MICROLIGHT AIRWORTHINESS APPROVAL NOTE

MAAN NO: 2996

TITLE: Microlight Airworthiness Approval Note 2996: Compulsory Service Bulletin reference cracks in the extruded bars of the main wing spar attachments

APPLICABILITY: UK (BMAA) MXP-740 Savannah aircraft, specifically: G-CCII (BMAA/HB/285)

Figure 1: Left front strut attachment to the spar

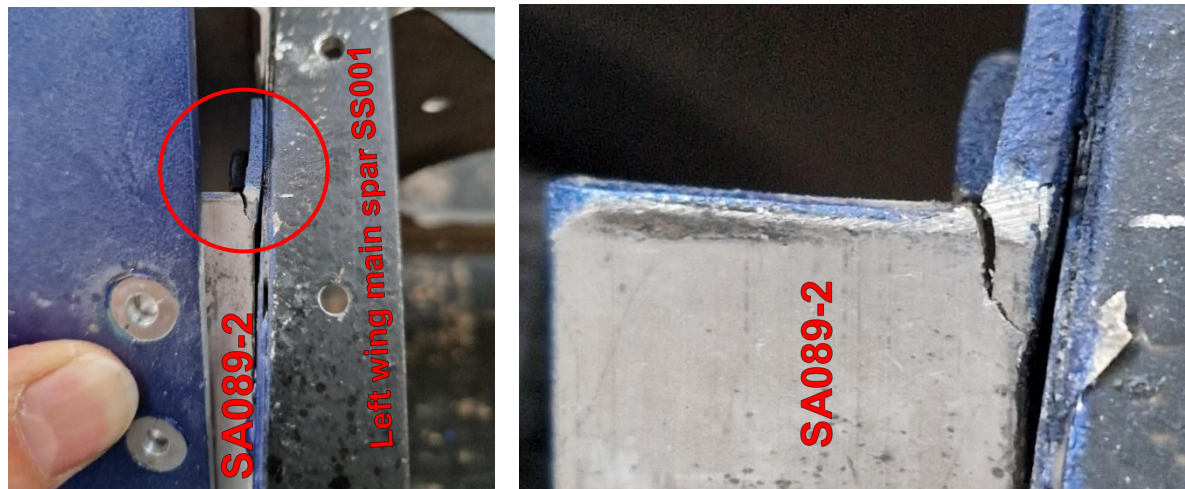
Replacement of the extruded bars of the main wing spar attachments: SA089-2 and SA090-2. See *Figure 1* and *Figure 2*.

On the *Savannah VG* aircraft, it has been discovered a crack on the subject parts, during a reparation of the wing.

Figure 3: Right Wing, partial opening of the upper skin, to access the area of intervention

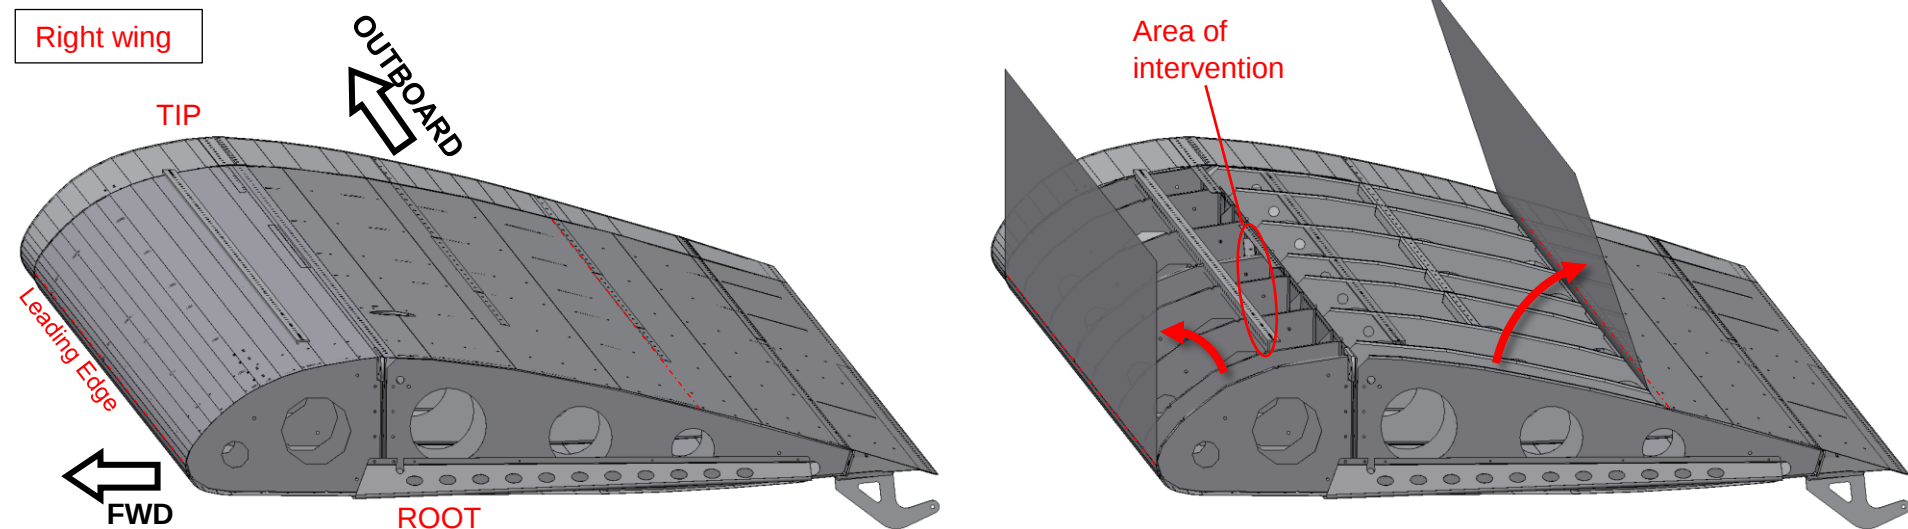
First, unrivet the L.E. skin: drill the pop rivets Ø3.2 [mm] and Ø4 [mm] with relative drill bits, then pull the skin up like shown in *Figure 3* (shown the right wing, do symmetrically on the left wing).

Then, unrivet the top skin: like before, drill the pop rivets and separate the skin from the spars, the ribs and the stringers below (if present) up to the last stringer before the rear spar (shown in *Figure 3*).

ATTENTION: Be very careful not to buckle the upper skin, while lifting it up.

Figure 4: Right Wing, area of intervention from the front

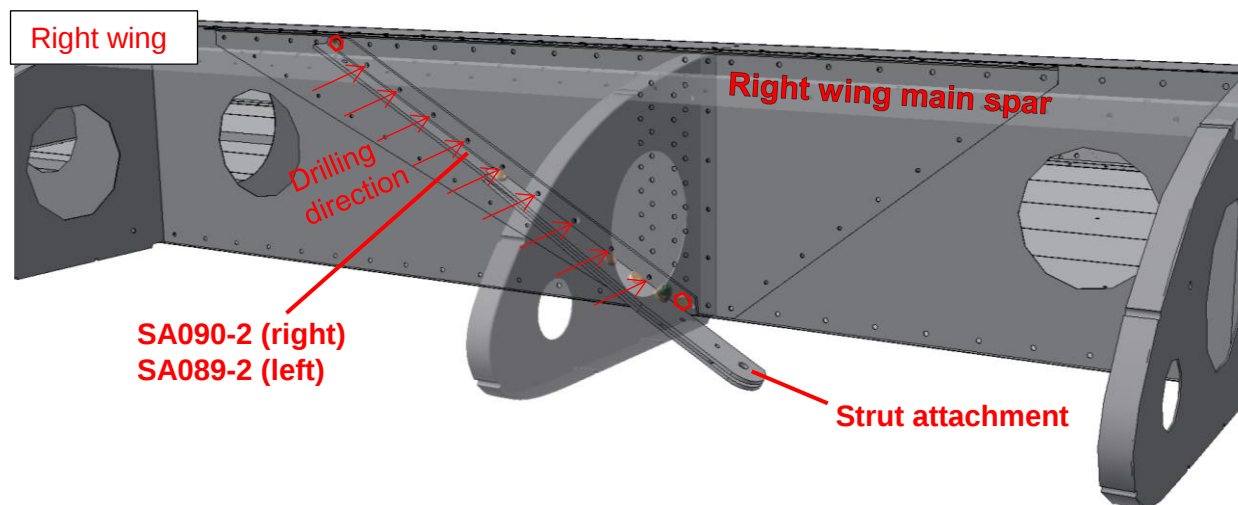
To remove the part SA090-2 from the right wing (SA089-2 on the left wing), drill $\varnothing 6$ [mm] just the tail of the solid rivets (from the front of the wing, like the view of *Figure 4*), in order to remove only the bulbous ends of the rivets.

Then, drill $\varnothing 4$ [mm] centered to the axis of the rivets, up to completely remove them. Pay attention to not excessively press the rivets when drilling, to not bend the main spar web.

Figure 5: Right Wing, area of intervention from behind

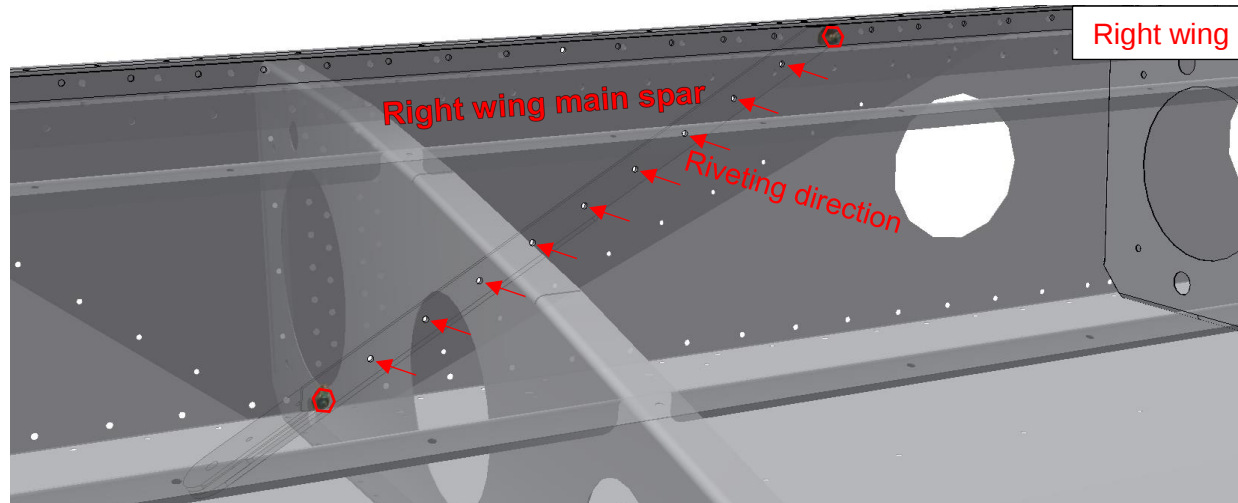
Now, install the new SA090-2 on the right (SA090-2 on the left) applying the following sequence of operations:

- Install the new set of AN3 bolts with self-locking nuts and washers, like shown in *Figure 5* and;
- Rivet the extruded part with Ø4 [mm] steel pop rivets to the main spar web.
ATTENTION: the head of the rivets must be oriented behind the spar, therefore the tail of rivets must be pressing on the extruded part, like shown in *Figure 5*;
- Reinstall the front strut attachment plates with the proper sequence of bolts, washers and self-locking nuts;
- Close all the AN3 bolts/nuts at 6 [Nm] with a torque wrench.

Figure 6: Right Wing, sequence of riveting top skins

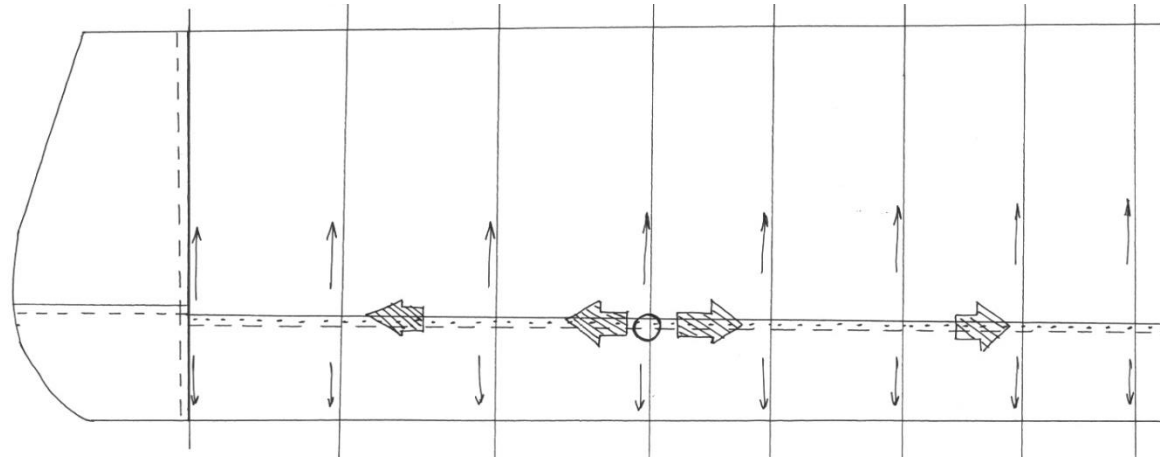
- Rivet entirely the top rear skin of the wing;
- Rivet entirely the top nose skin of the wing.

ATTENTION: The riveting sequence must follow a certain order, as explained in *Figure 6*, also according to the *Construction Manual* of the airplane (Wing Chapters);
